MONTEREY COUNTY PLANNING COMMISSION

Meeting: October 9, 2013 Time: 9:00 A.M		Agenda Item No. 1
Project Description: Combined Development Permit as an after-the-fact permit consisting of: 1) Coastal Development Permit allowing bluff stabilization/erosion control to prevent structural damage from tidal erosion of terrace deposits and overlying soils. The artificial rock fascia is designed to match the existing shoreline contour, texture and color; 2) a Coastal Development Permit to allow development within 100 feet of environmentally sensitive habitat; 3) a Coastal Development Permit to allow development on slopes of 30% or greater; and 4) a Coastal Development Permit for development within 750 feet of a known archaeological resource.		
Project Location: 3158 17-Mile Drive in the Del Monte Forest area of Pebble Beach		APN: 008-491-013-000
Planning File Number: PLN100670		Owner: Peter Read Agent: Bud Carney
Plan Area: Del Monte Forest Land Use Plan (Coastal Zone)		Flagged and staked: No

EXHIBIT G
READ (PLN100670)
COMMENTS ON NEGATIVE DECLARATION FROM COASTAL
COMMISSION

AS BUILT BLUFF PROTECTION PLAN
READ PROPERTY AS BUILT COASTAL BLUFF PROTECTION
3158 SEVENTEEN MILE DRIVE, PEBBLE BEACH, CA
MONTEREY COUNTY A.P.N. 008-491-13

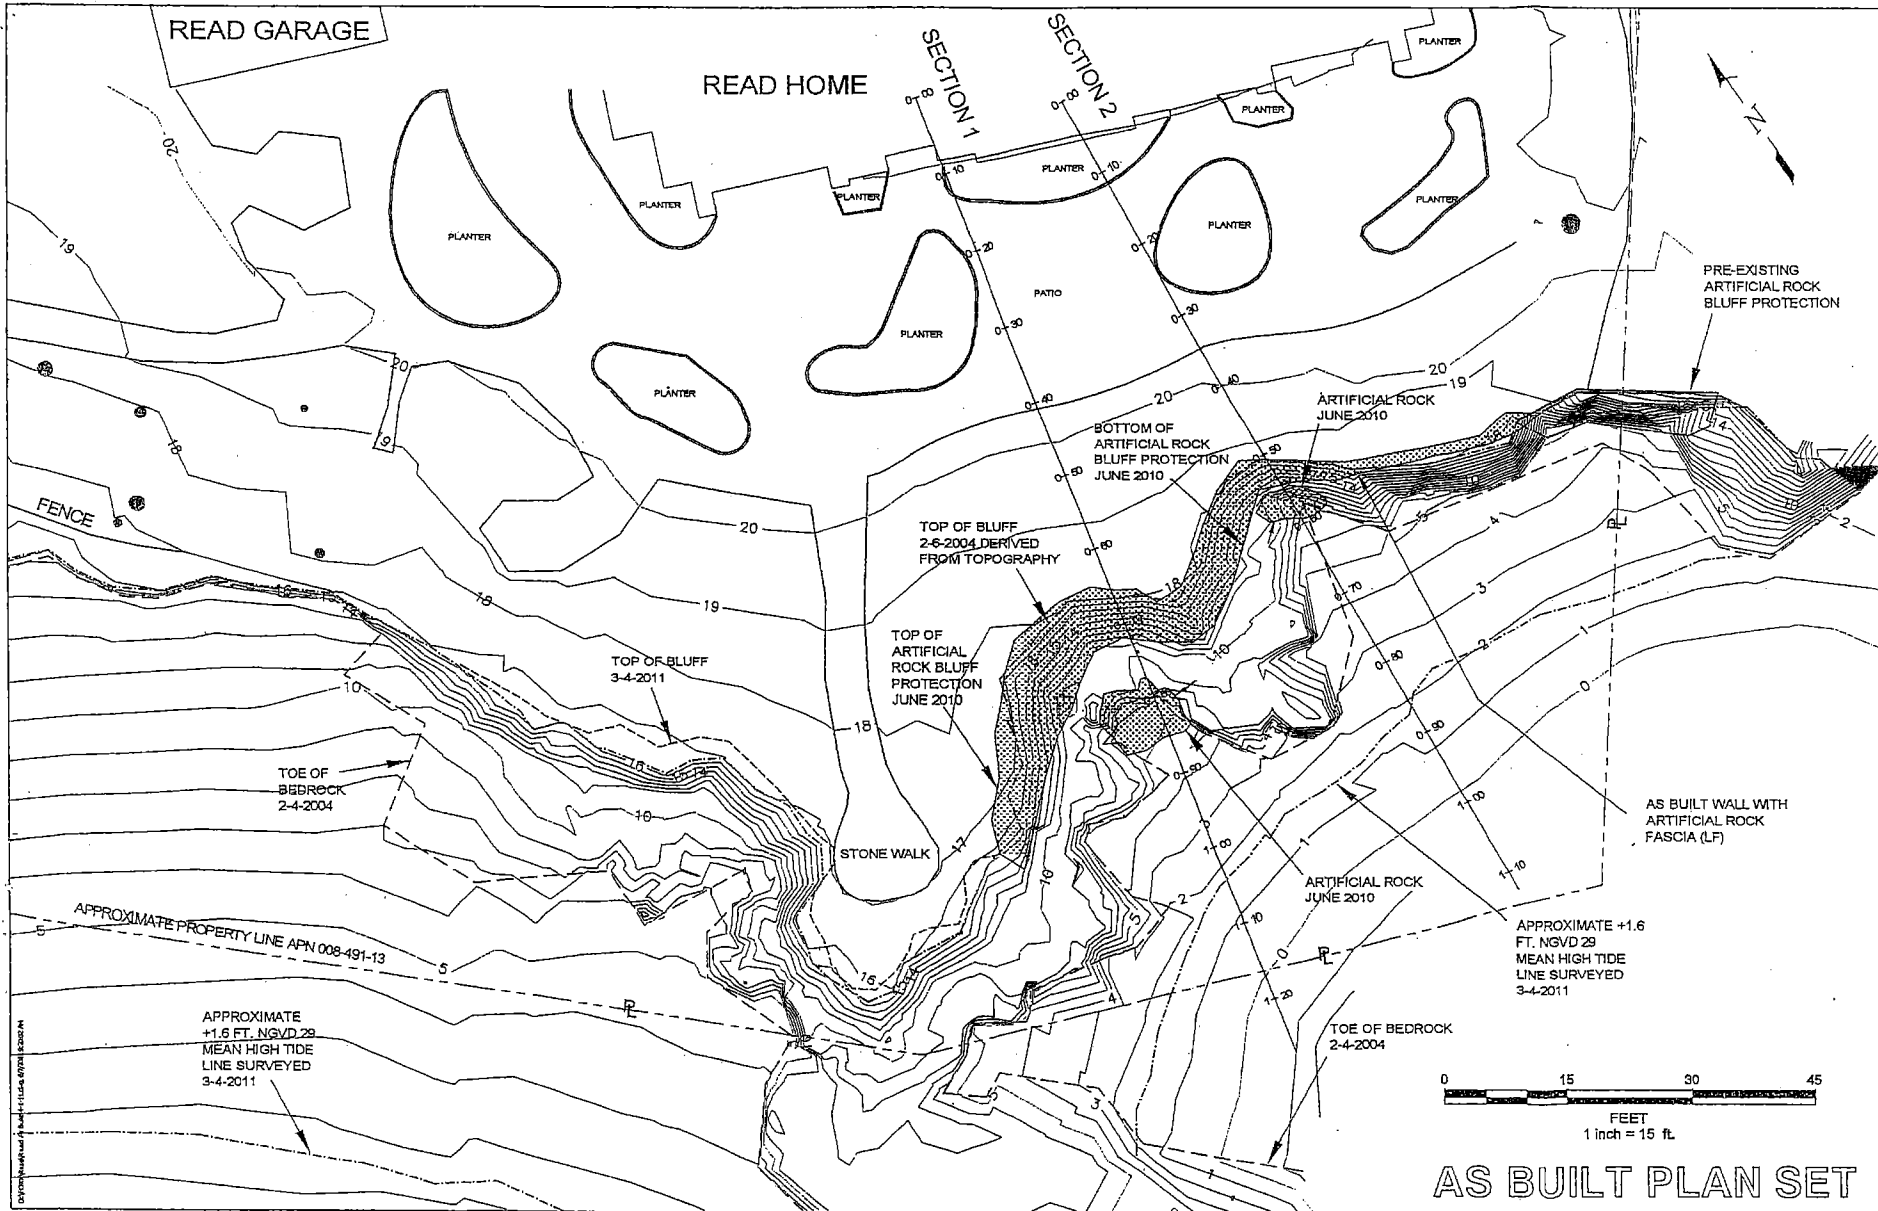
As shown on Sheet 2 of the Bluff Protection Plans the erosion control fascia is typically 20 to 25 feet landward of the surveyed MHTL, with the closest point being 16 feet from the surveyed MHTL. We were present at the site during the MHTL field survey. The beach area where the MHTL was surveyed consisted of bedrock, small boulders and cobbles at the time of the survey.

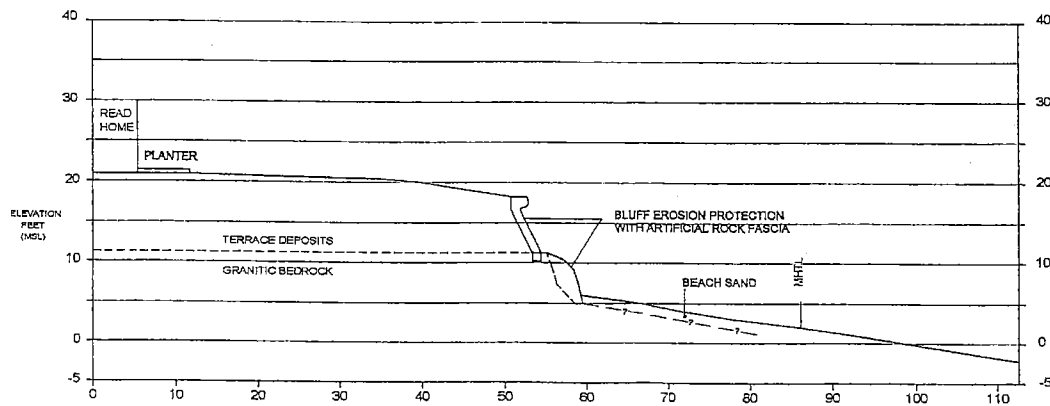
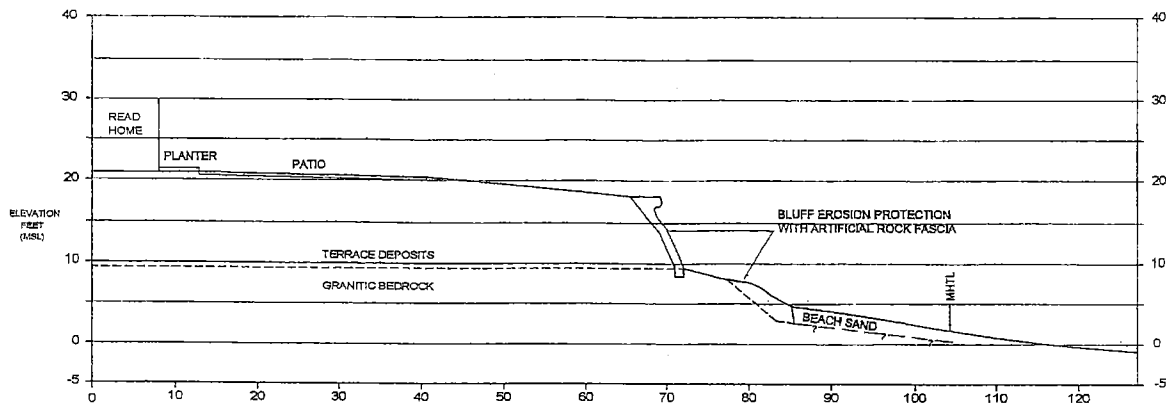
We reviewed the cross sections on Sheet 3 of the Read Property As Built Bluff Protection Plans, dated 4/1/2011 and the lowest portion of the erosion protection fascia meets the beach profile above elevation +4 NGVD. This in a location well landward of the MHTL position, the location of which is indicated on the cross sections.

Figure 5. Projected 50, 75, 100 - year erosion lines from top of coastal bluff, from Nielsen and Associates (2004)

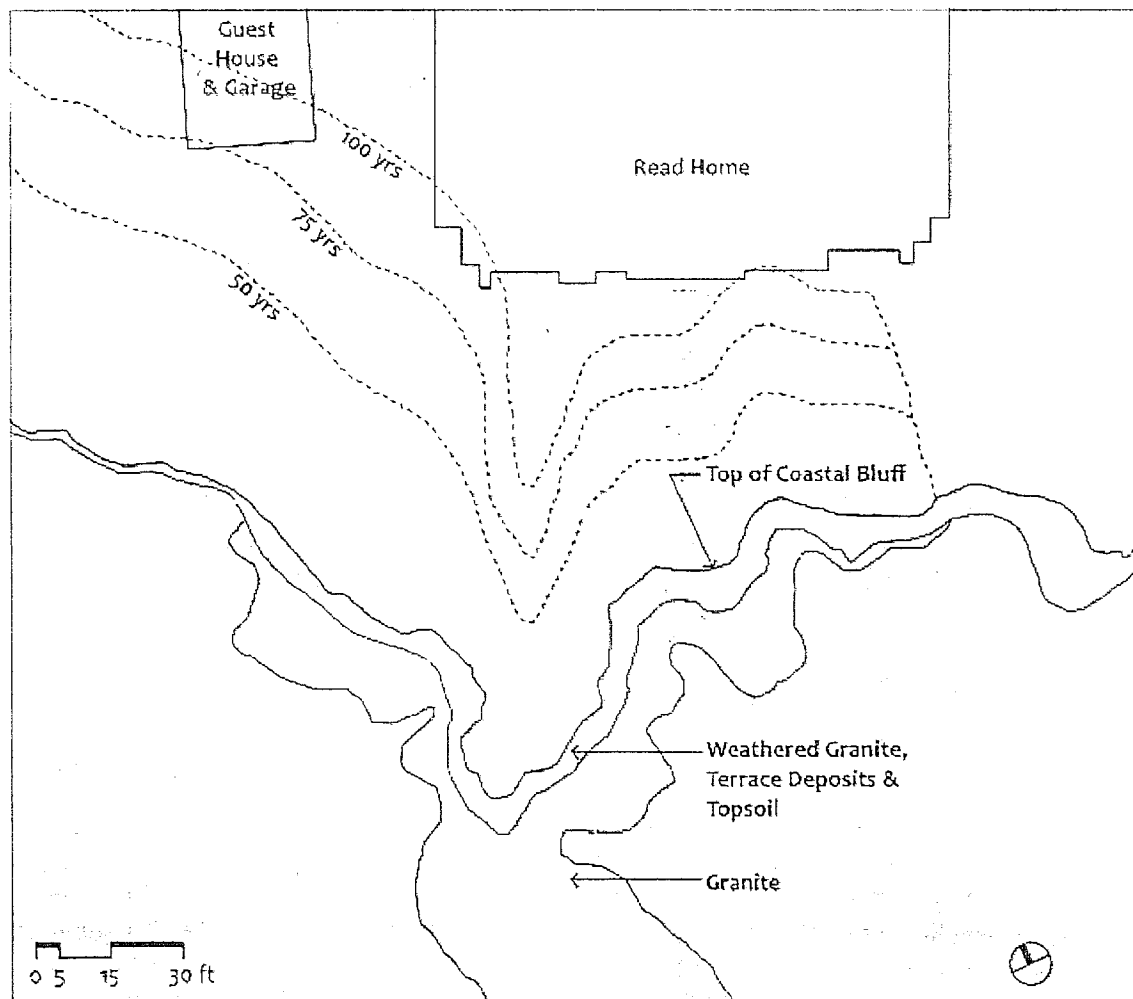
The Coastal Commission submitted a letter (**Exhibit I**) dated July 26, 2013 with comments on the additional information that was provided following their initial comments on the Negative Declaration. Based on an examination of Figure 5 in the Geologic Report (**Exhibit K**), the Coastal Commission letter states that "*it appears that the Read home, guest house and garage would be safe for another 50 years and therefore these structures are not in imminent danger from erosion.*" The letter further states that the closest development to the bluff edge includes the stone walk and planters, which are located within 7-10 feet of the bluff edge. However, these elements do not constitute "*substantial structures*", as defined in IP Section 20.147.060(B)(7), and thus do not warrant protection under the LCP.

project alternative). Even with the new estimated rate of erosion of 0.5 feet per year, the Read home is not "in danger" from erosion as defined by the LCP or Coastal Act. From examination of Figure 5 in Dr. Griggs' report (which illustrates the projected 50, 75, and 100 year erosion lines of the bluff from an analysis done by Nielsen and Associates (2004) which assumed a bluff erosion rate between 0.45 and 0.75 feet per year) it appears that the Read home, guest house, and garage would be safe for another 50 years, and therefore these structures are not in imminent danger from erosion. In addition, Figure 5 also suggests that the portion of the bluff that would intersect the Read guest house within 75 years is located at the western property end, and not the southern end of the property where the bluff has been armored. If the property owner plans to protect his home from bluff erosion occurring on the western end of the property, then this would suggest that future bluff protection may need to occur near Otter Cove in closer proximity to environmentally sensitive habitat areas (ESHA).
